28 Willoughby Road  
London NW3 1SA

Basement Impact Assessment  
Audit

London Borough of Camden

Project Number: 12466-67

**P17 - PROPOSED DRAINAGE PLAN**

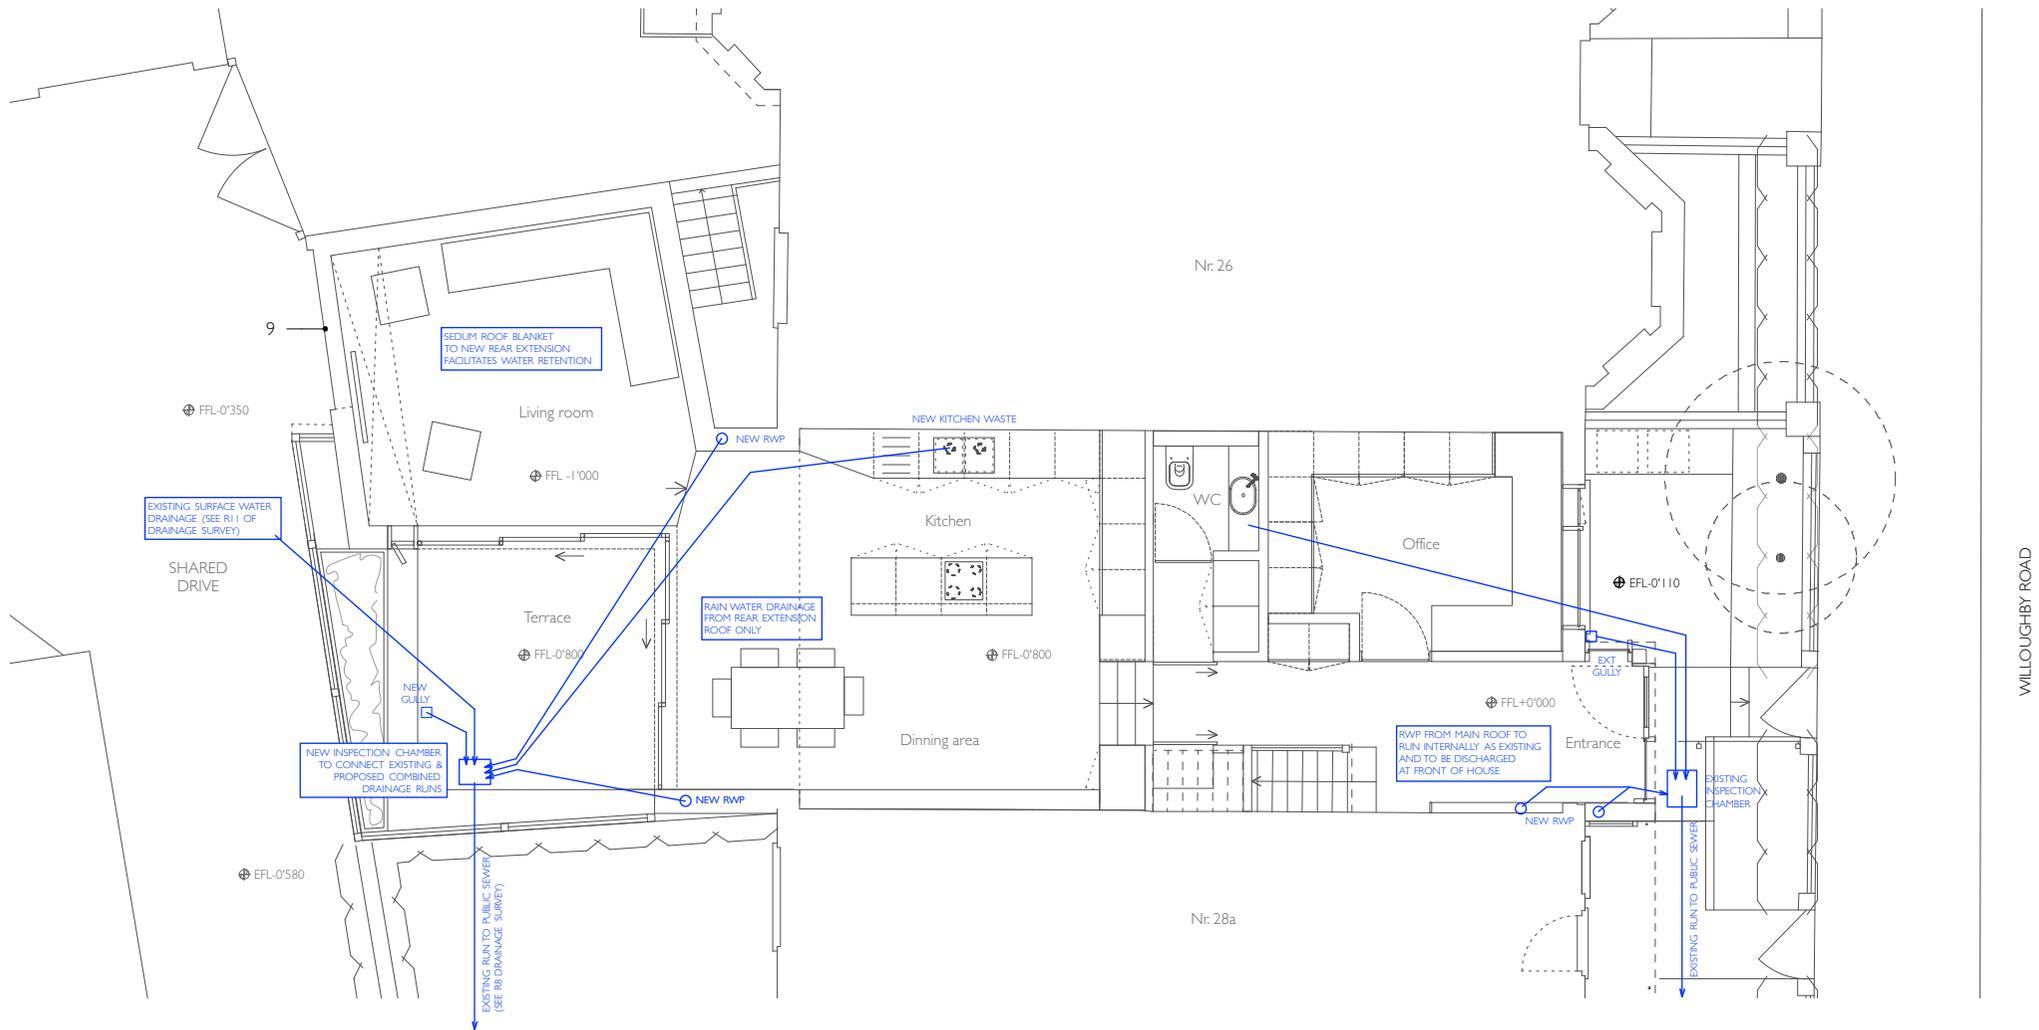
- 4.8. It is accepted that the site not in a Flood Risk Zone and is at low risk of flooding.
- 4.9. There is inconsistency with the change in impermeable site area due to the proposed development between and within the provided sources. A review of the drawings provided indicates that there will be an impact to surface water drainage and flow. The proposed drainage plan indicates that a Sedum roof blanket is proposed on the new rear to offset the increase in impermeable surface area. The adequacy of this is a solution should be confirmed at detailed design, and should be augmented if required to meet LBC's attenuation requirements.

- 5.5. The proposed development increases the impermeable area of the site. A sedum roof blanket is proposed to mitigate the increase. This should be confirmed for adequacy during detailed design, augmented if required, and an attenuation scheme implemented that meets LBC's requirements.
